Anderson Bank Building Background

Anderson Bank Building Brief Alterations & Applications Background 203 G / 719 2nd Streets

REPORT: PROJECT PROPOSAL
CITY OF DAVIS
ANDERSON BUILDING, 203 G STREET

Subject: Design Review - 203 G Street

SAW CUT BRICK WINDOW SILL **2**

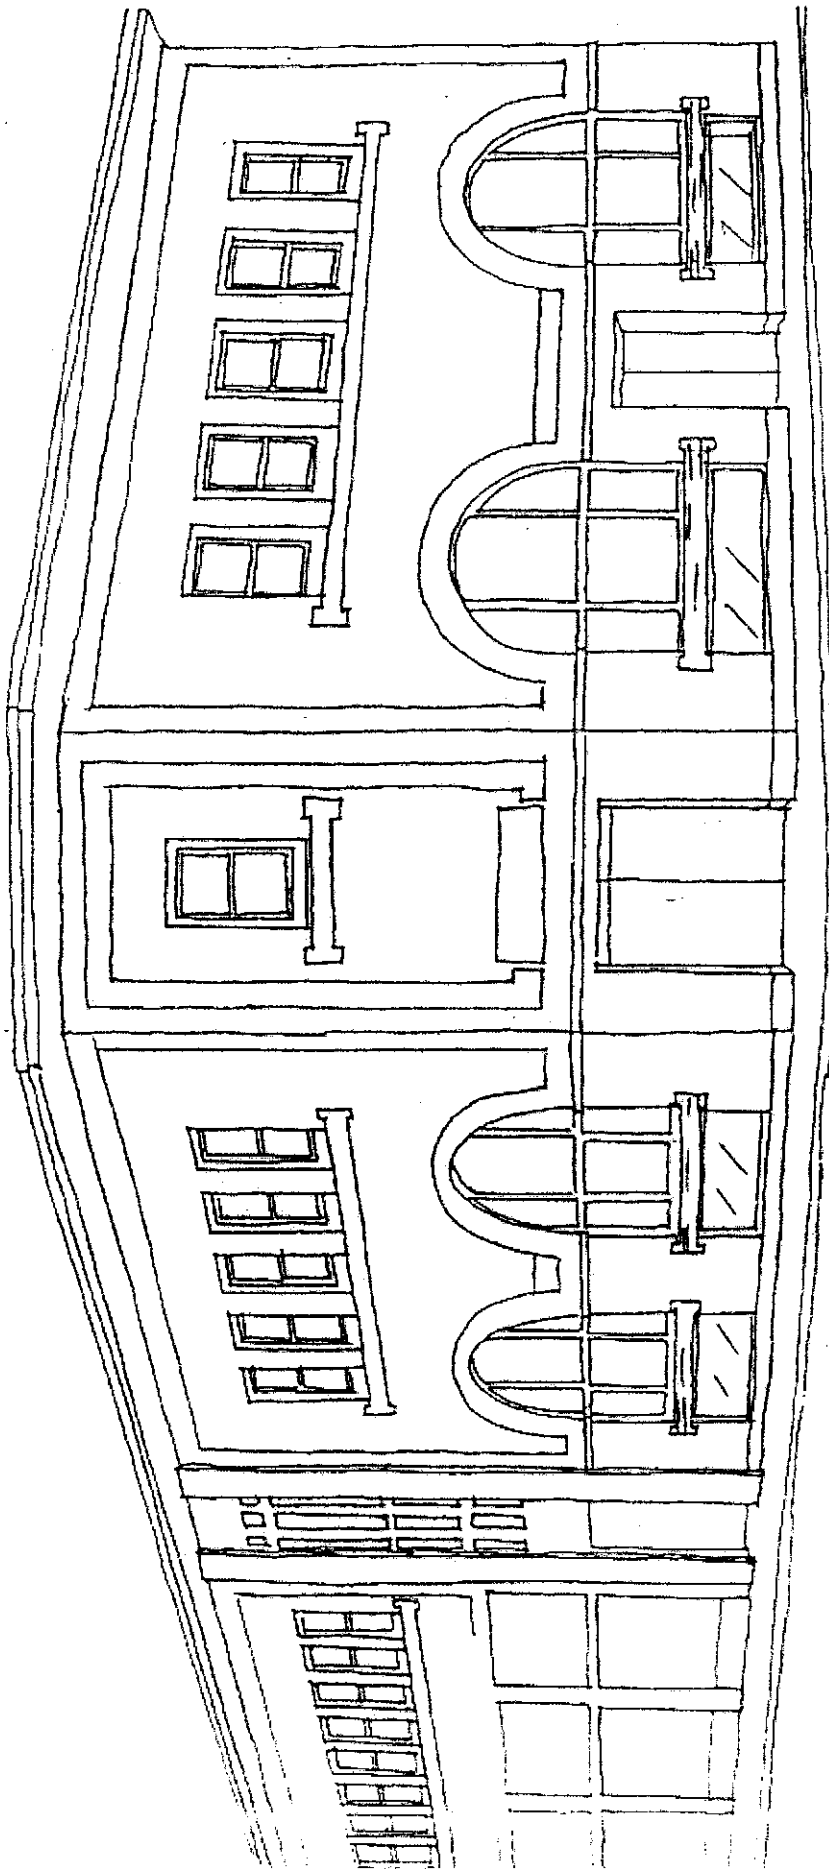
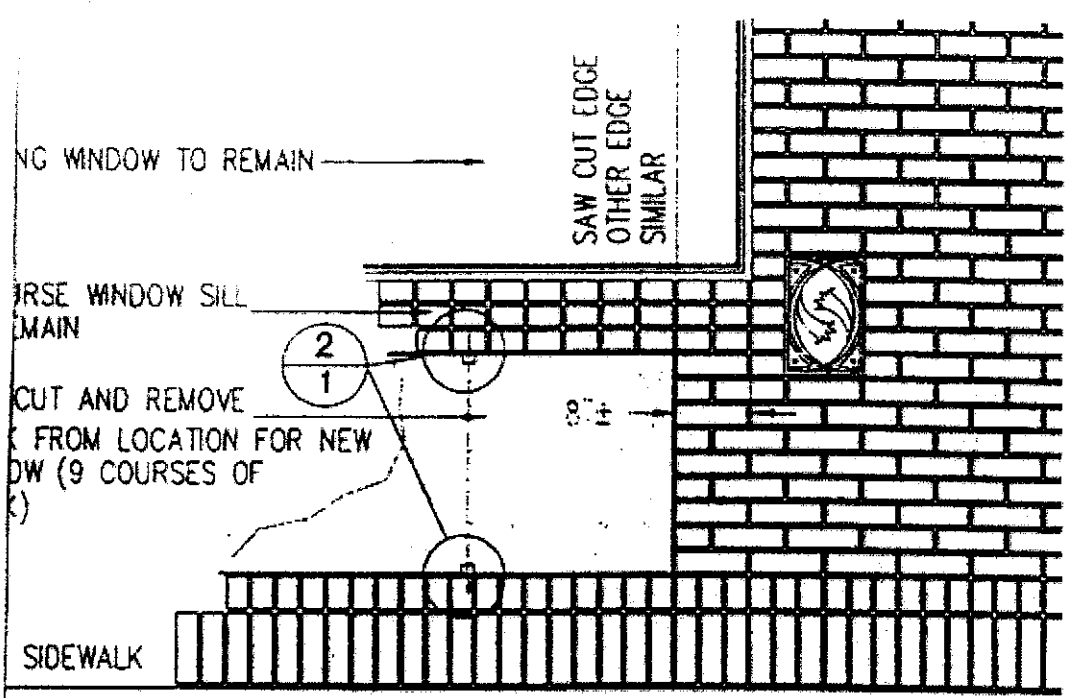
The second alternative is similar to the first. It involves the removal of the brick below the windows from the top and the base course to the underside of the wood windowsill. A steel tube would be installed below the sill to carry the structural loads of the window. The glass would be held in place with similar metal clips and its edges sealed to the brick and top steel tube with clear silicone sealant.

SAW CUT BRICK WINDOW SILL **1**

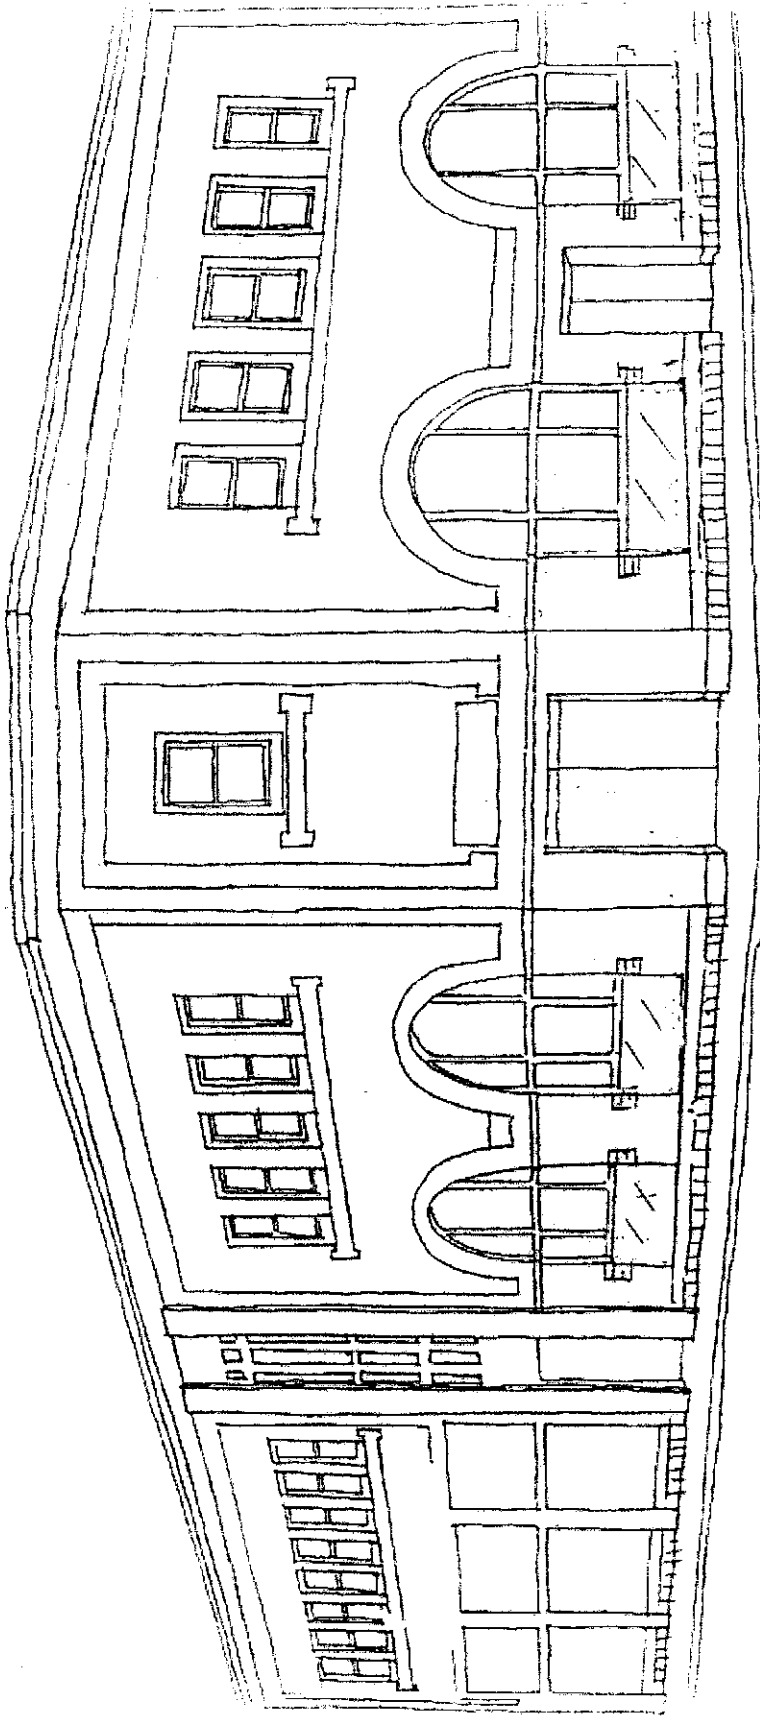
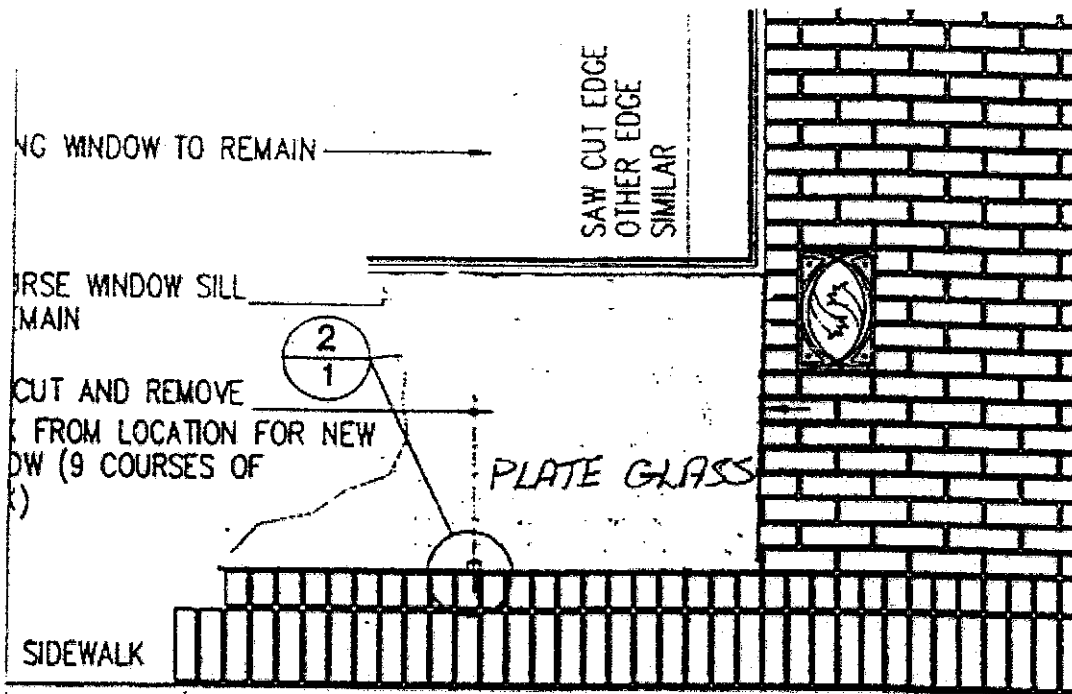
The first alternative involves the removal of the existing brick below the four arched windows, starting at the top of the existing base course brick and extending upwards to a point three courses of brick below the existing windowsill. The width of the removed brick would match the width of the existing window above. The top three courses of remaining brick would be supported by an interior (not visible from the exterior) steel tube and a thin metal plate under the bricks.

Clear tempered glass would be placed in the opening created by the removed brick. Its outside surface would align with the adjoining brick. The glass would be held in place with small metal clips, located at intermittent positions at the top and bottom of the glass. The edges of the glass would be sealed to the brick ends with clear silicone sealant.

Both alternatives provide new façade openings that appear significantly different than existing openings. As the new glass is essentially frameless, it is clearly of a type and style of construction that is new and not historic in appearance.

By placing the glass at the plane of the brick, it occurs in a different plane than the glass of the existing windows above it. By reducing the treatment of the glass to a frameless condition, the new glazing does not mimic the existing wood framed windows. The glass appears, instead, to become a substitute for the removed brick.
